ADDENDUM NO. 4

ATTLEBORO WATER DEPARTMENT

WADING RIVER WATER TREATMENT PLANT

CONTRACT NO. 10

SECTION DETAIL AT CANOPY

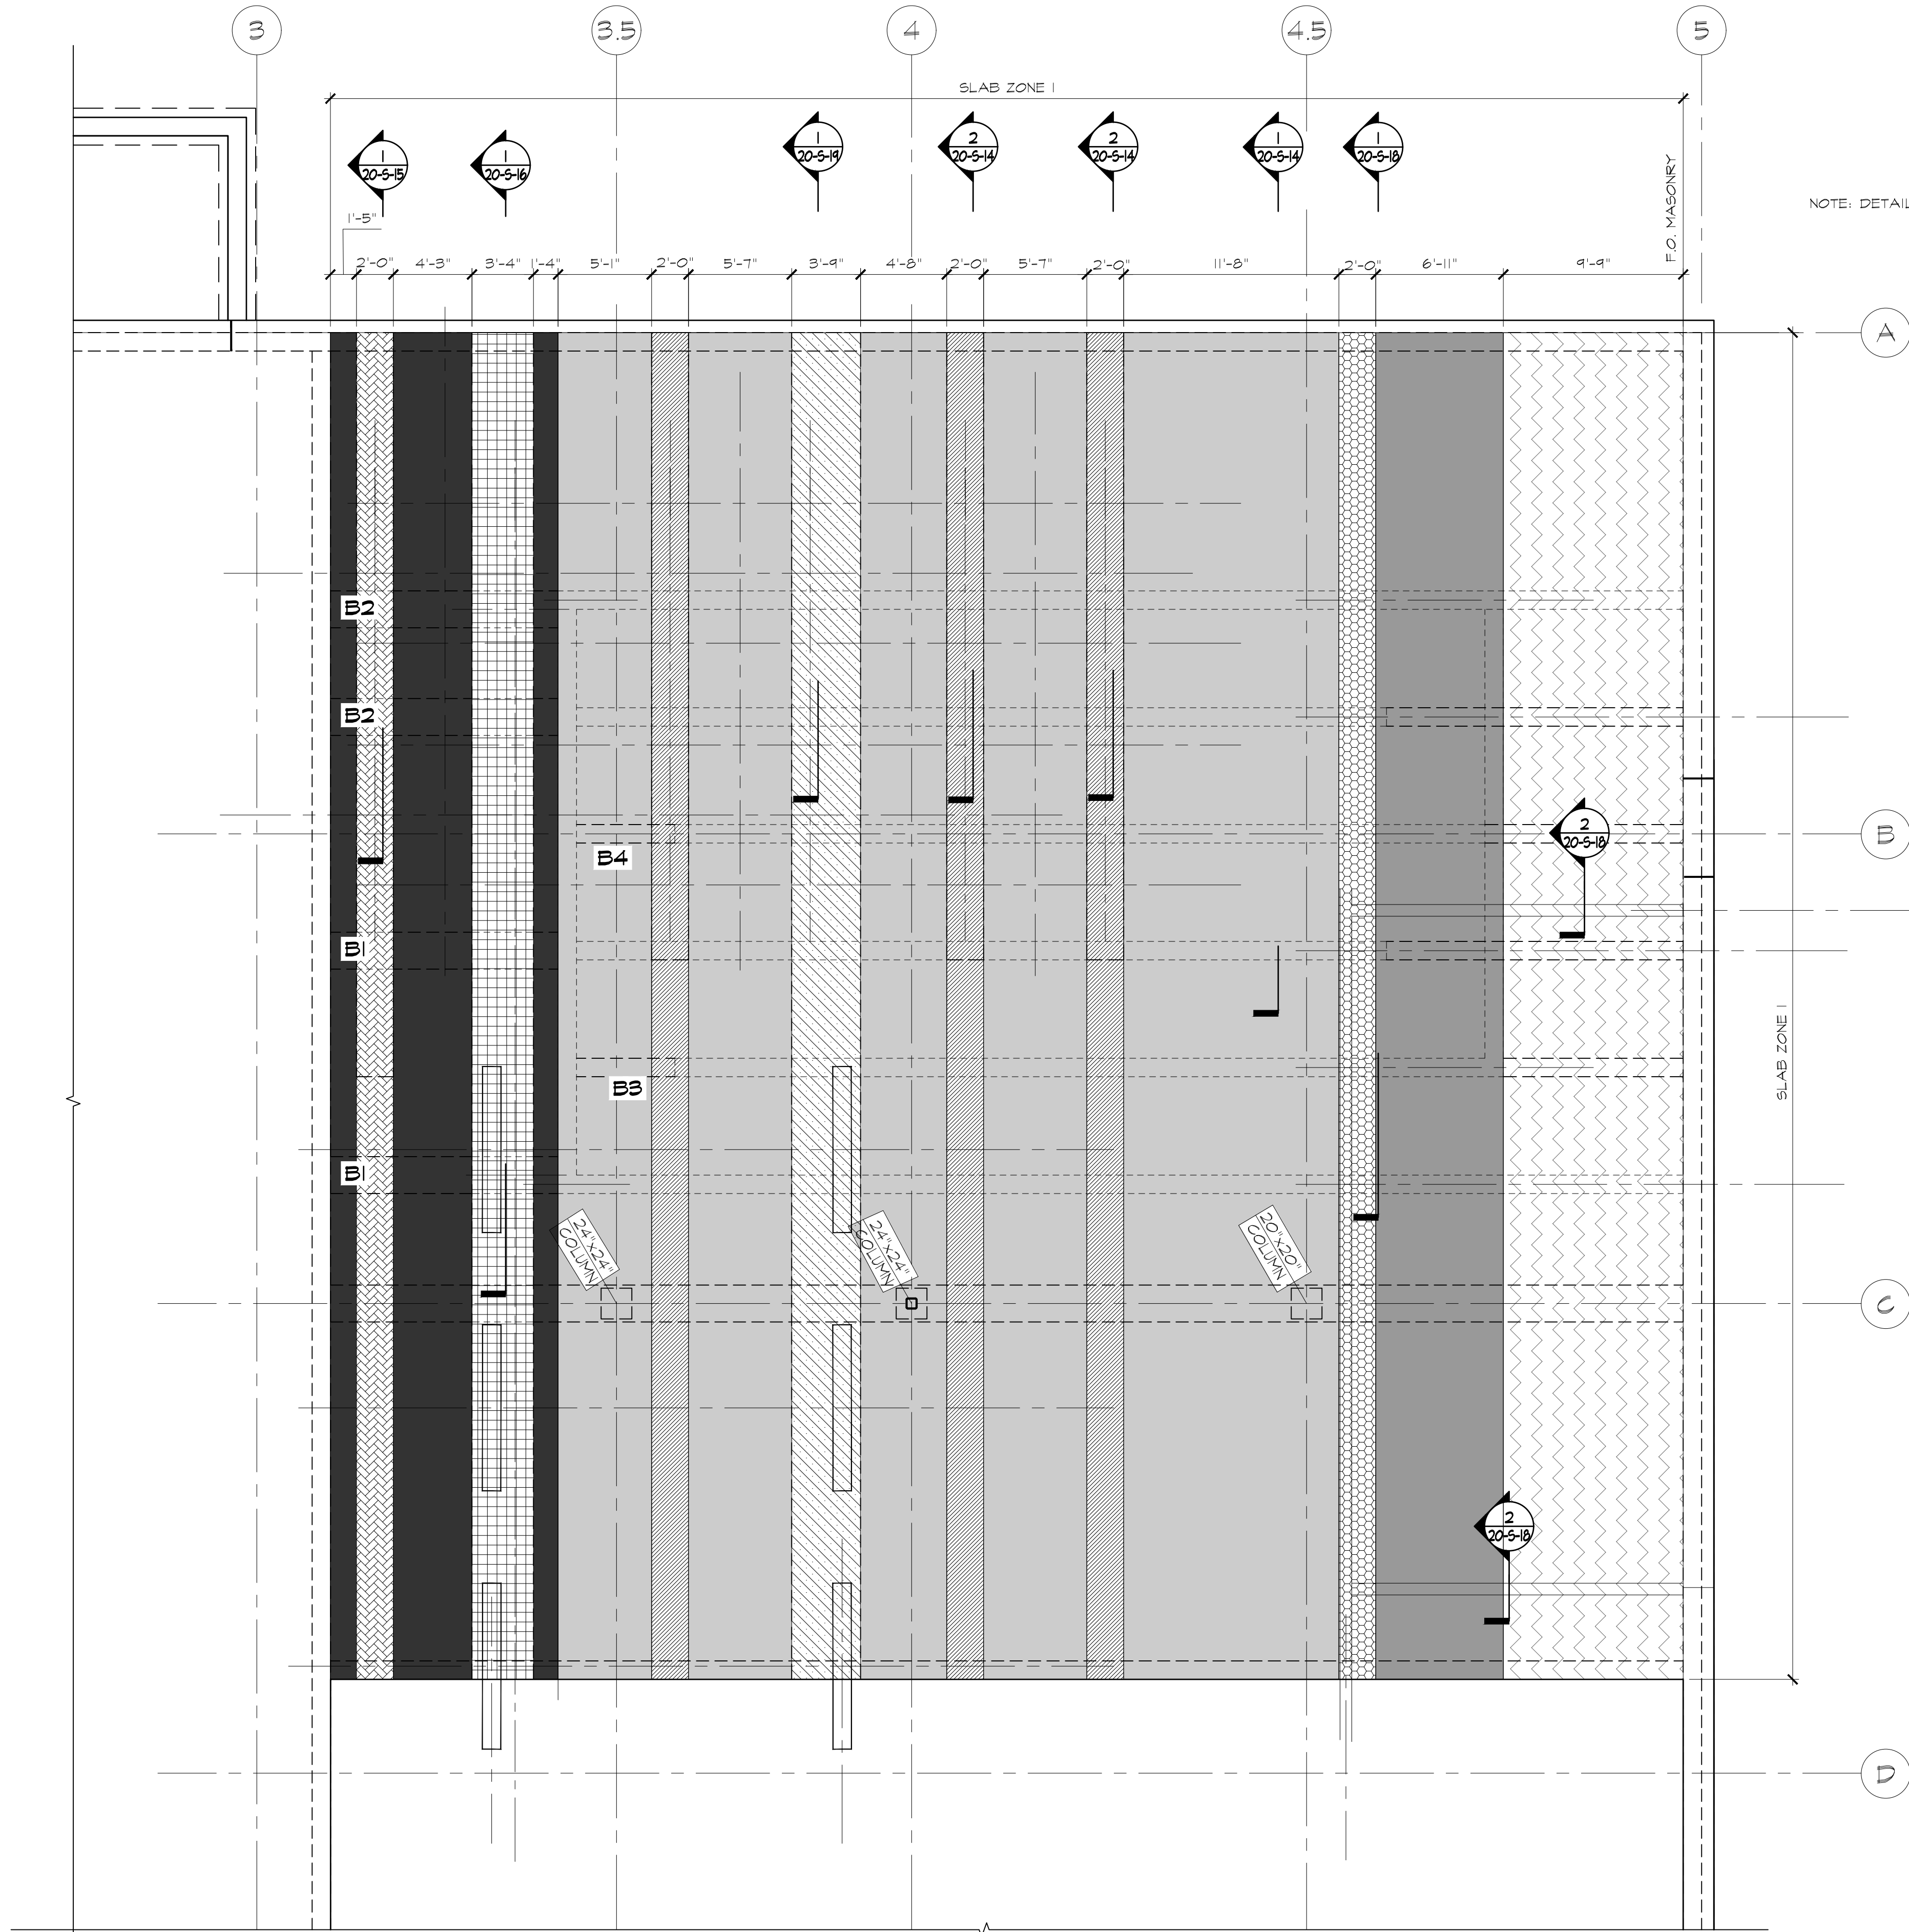
1. Reference Drawing 99-A-1, delete ‘Typical Metal Awing Detail’ and replace with Canopy per Sketch ‘SK-A-001’ – Section Detail at Canopy, attached this addendum.

20-S-2a

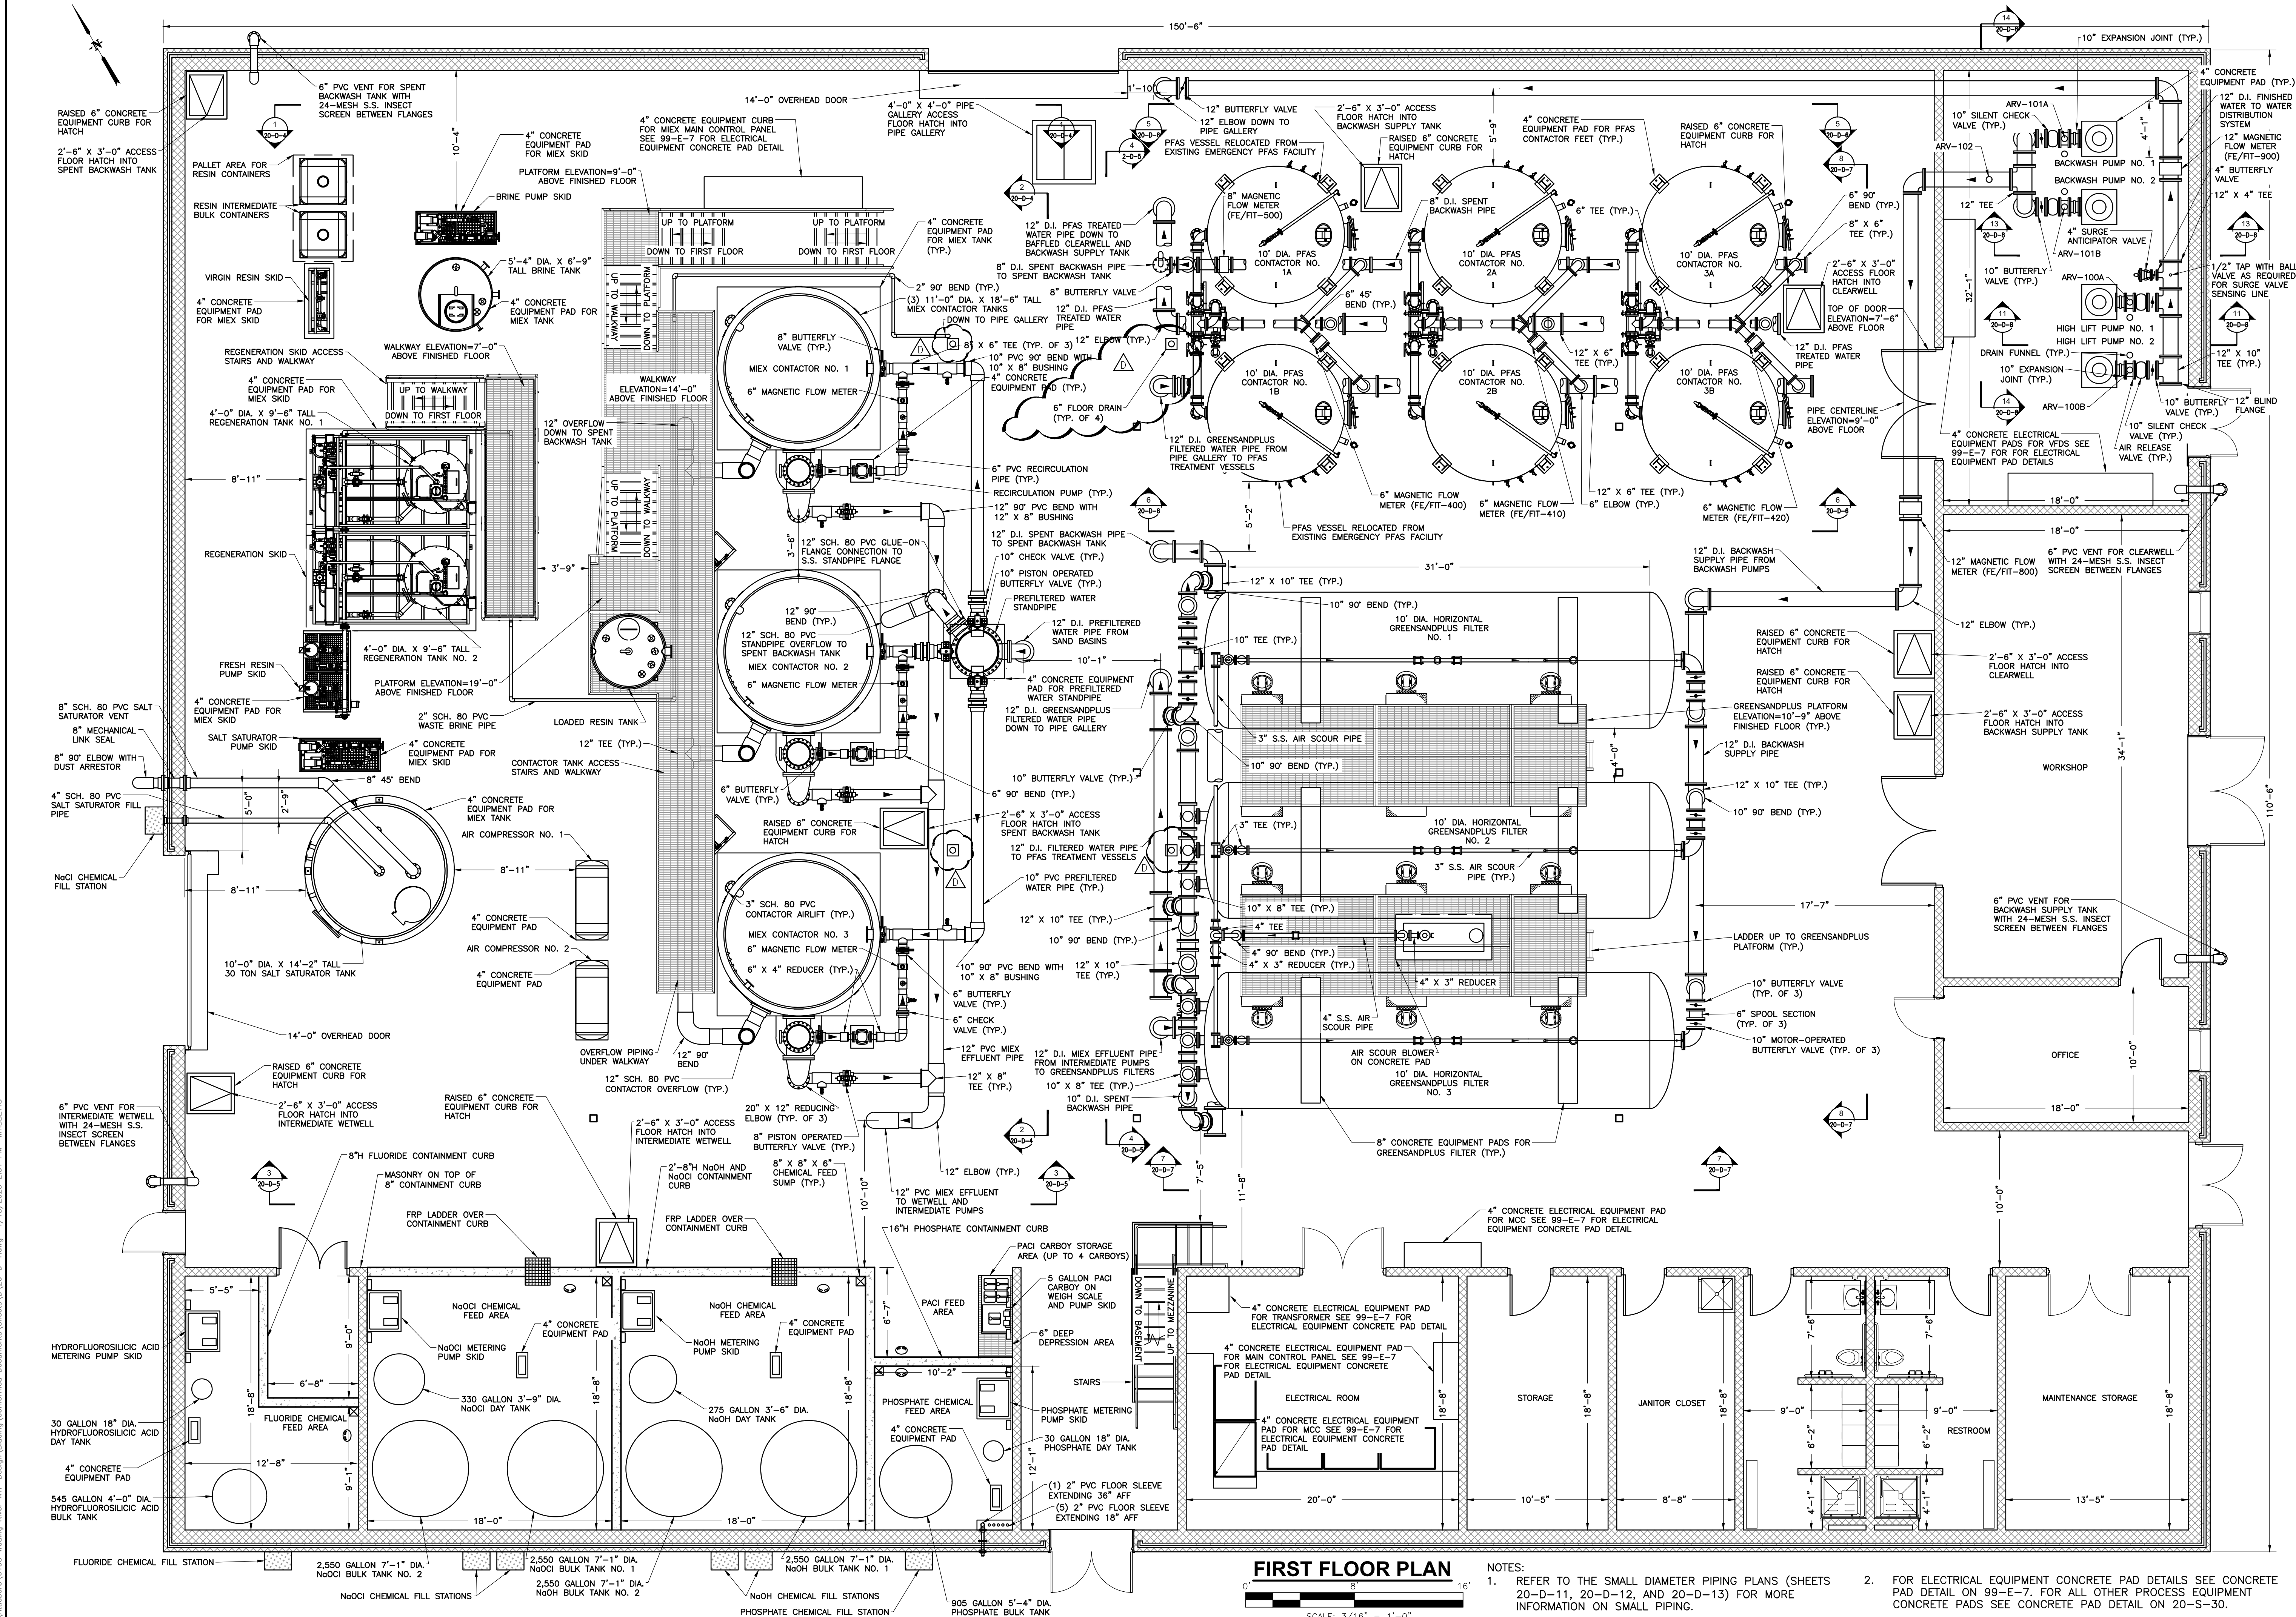
Q17: Can you please clarify the Slab zone types on 20-S-2a. There are three black conditions. Since the plans are black and white, they all look the same.

1. Reference Drawing 02-S-1, Structural Foundation Plan, Footing Schedule, Mark F5, delete ‘Build Integral w/Tank Slab’ under ‘Notes’ column.
2. Reference Drawing 02-S-2a, Structural Slab Zone 1 – Design Layout Plan, delete in its entirety and replace with the revised 02-S-2a, attached this addendum.

A17: *Sheet 20-S-2a became corrupt while compiling the complete contract drawing PDF document. A revised Sheet 20-S-2a is attached to this addendum with the correct shading.*

ATTLEBORO WATER DEPT. ATTLEBORO, MA	WADING RIVER WATER TREATMENT PLANT
PROCESS FIRST FLOOR PLAN	
SHEET NO. 20-D-1 DATE: APRIL 2025 SCALE: AS NOTED	DRAWN BY: M.J. RSP DESIGNED BY: M.M. APPROVED BY: K.L.G.

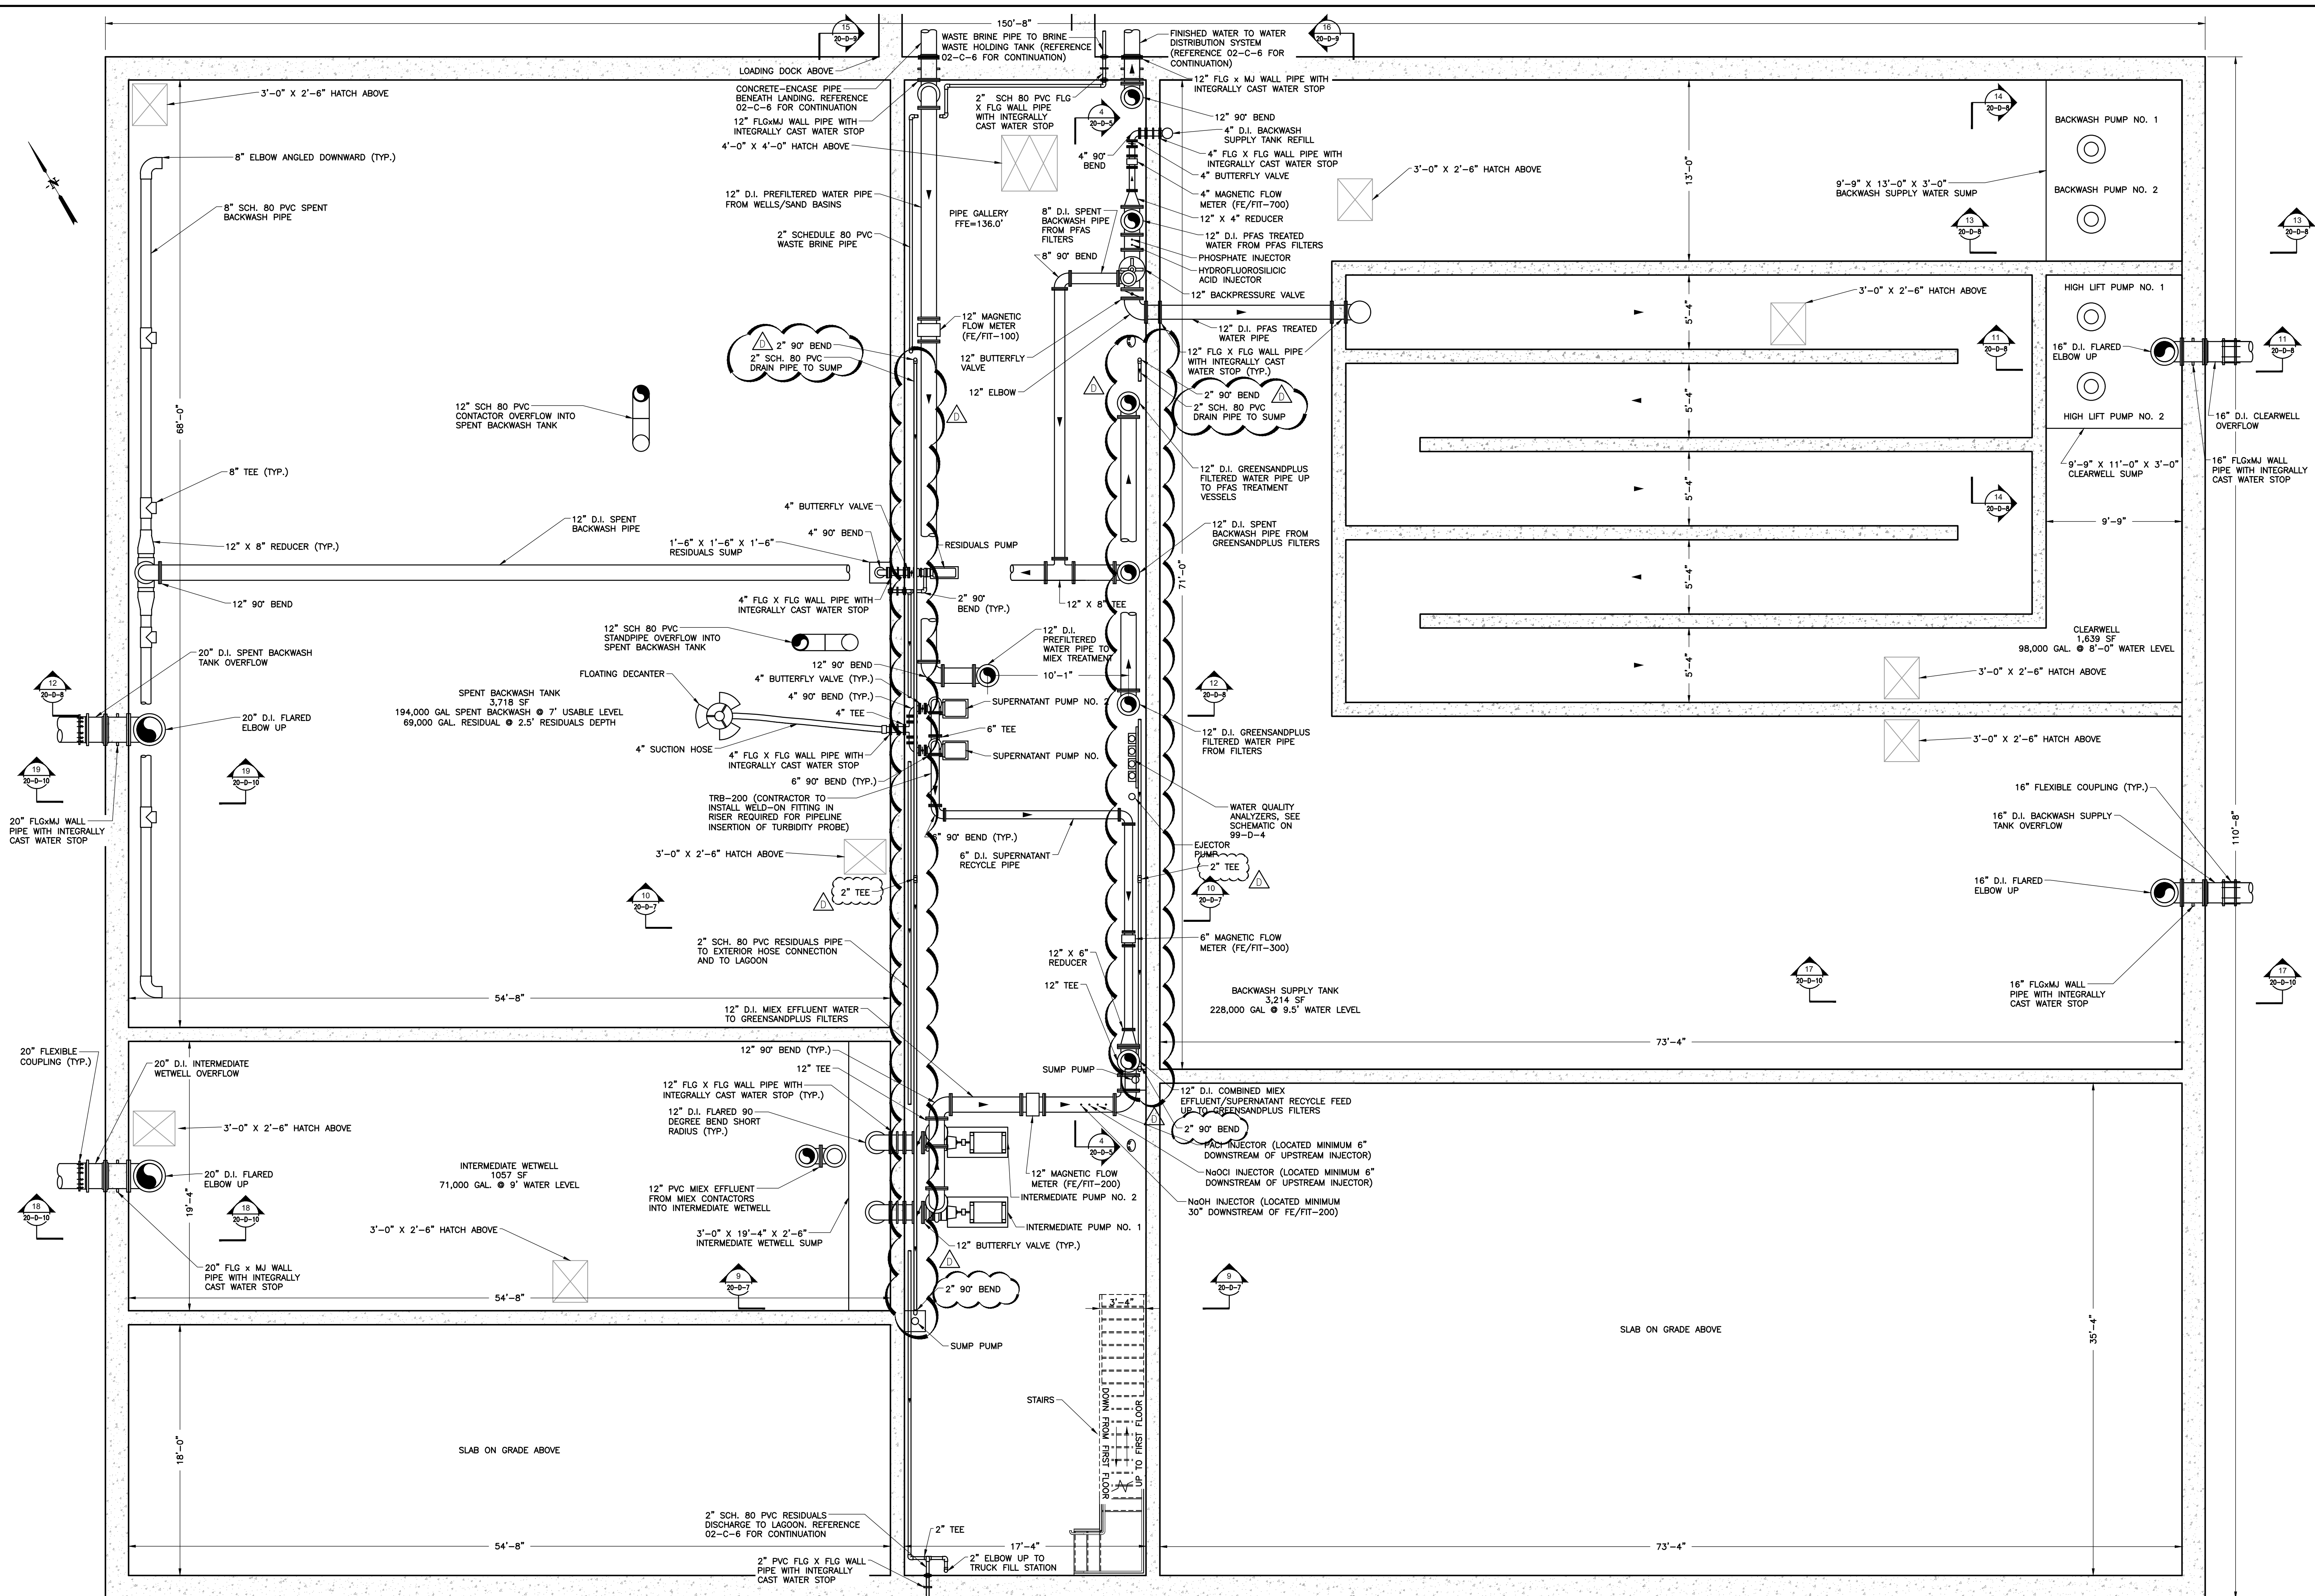
Delete and replace these drawings with attached revised 20-D-1, 20-D-2, 20-D-9 drawings. Revisions to noted drawings include four (4) 6-inch floor drains that drain down into the sumps in the pipe gallery via 2-inch Schedule 80 PVC Piping.
